New roof windows to attic conversion.

22/04083/FUL

## **Attachment D- Planning Permission - Full case for appeal**

**Application for Planning Permission**  
**3F2 9 Marchmont Street, Edinburgh, EH9 1EL**

drawing title  
**PROPOSED PLANS, ELEVATIONS & SECTION**

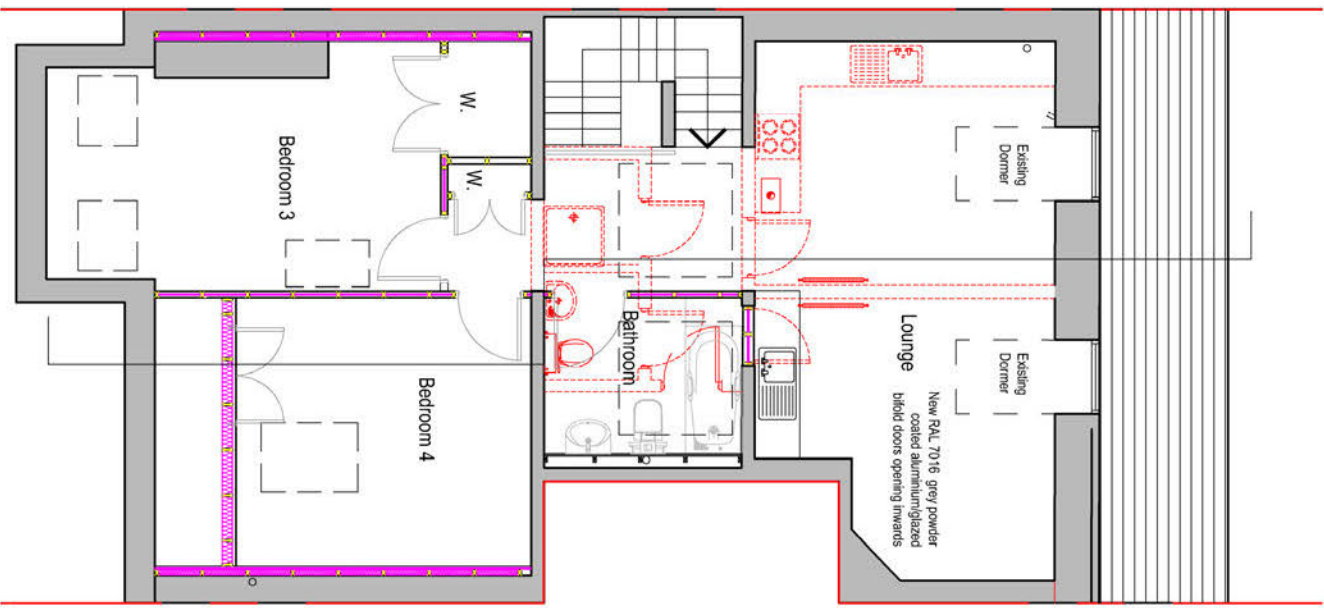
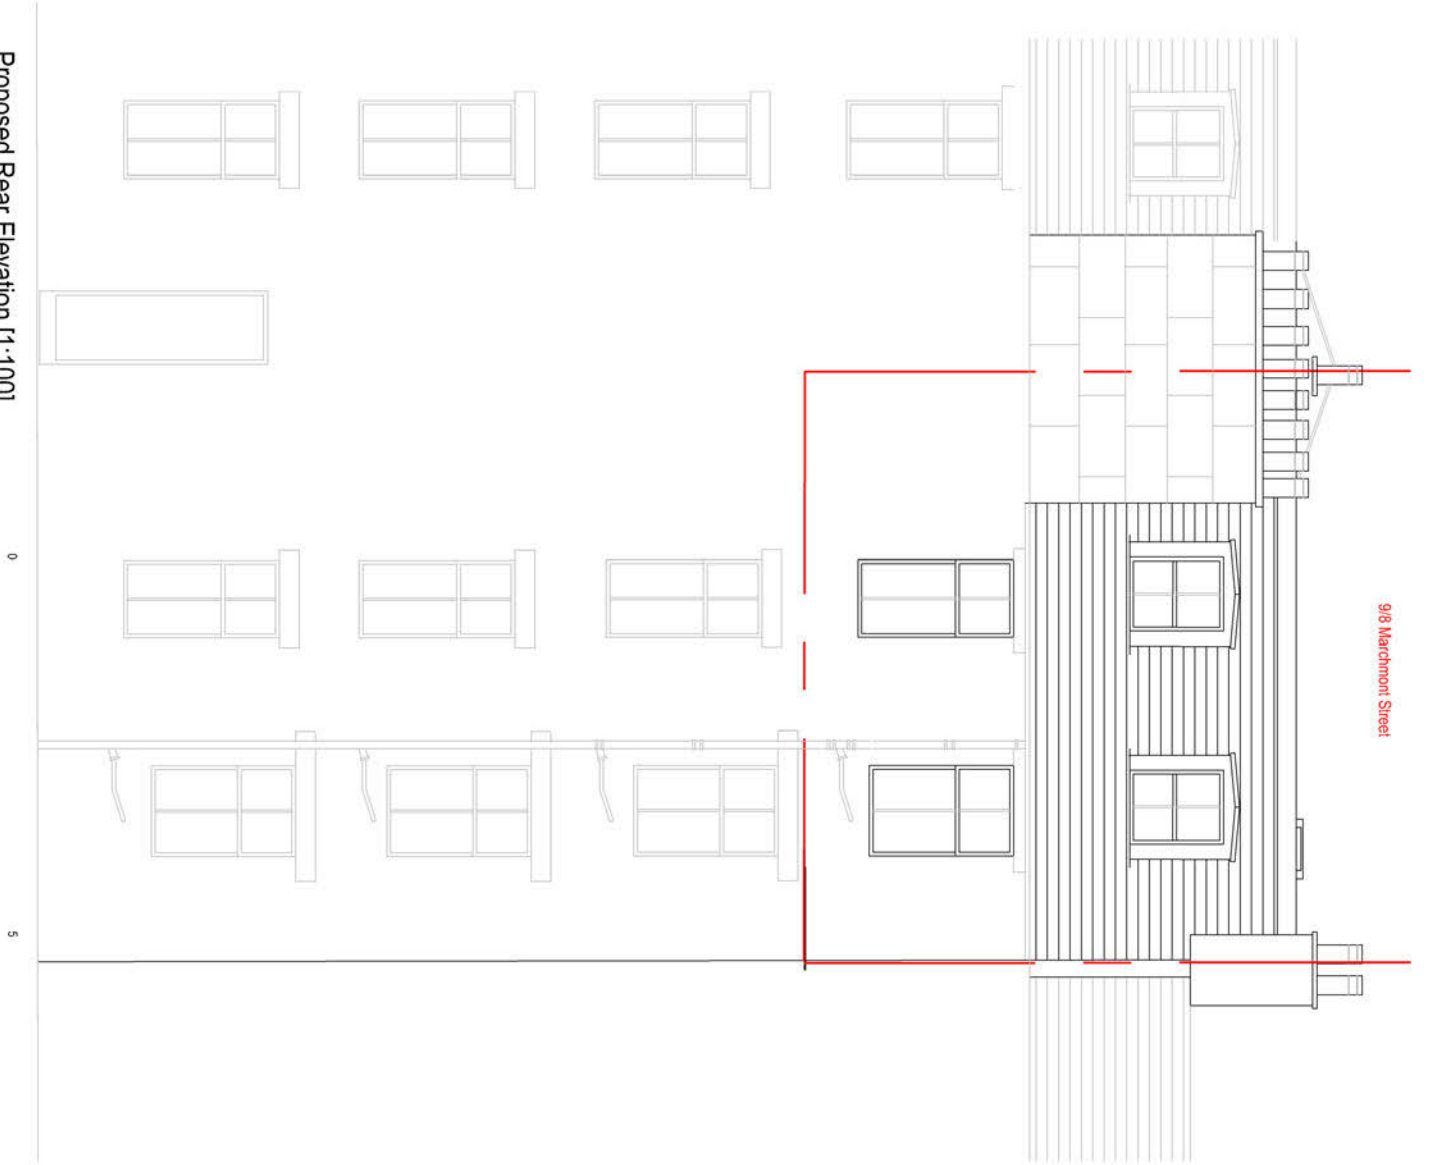
It is not the use of rooflights as such, the principle of rooflights is fine, but the ones on the roof over the forward bay projection are not, as they are far too prominent and would be visible along the length of the street.

The addition of rooflights on this section of roof would adversely impact on the character. It is also noted that one of the proposed rooflights on the main roof plane is somewhat large and fails to adopt a "conservation style".

1. The proposal is contrary to the Local Development Plan Policy Env 4 in respect of Listed Buildings - Alterations and Extensions, as the rooflights would have an adverse impact on the character of the listed building.

2. The proposal is contrary to the Local Development Plan Policy Env 6 in respect of Conservation Areas - Development, as the proposed rooflights would have an adverse impact on the character and appearance of the conservation area.
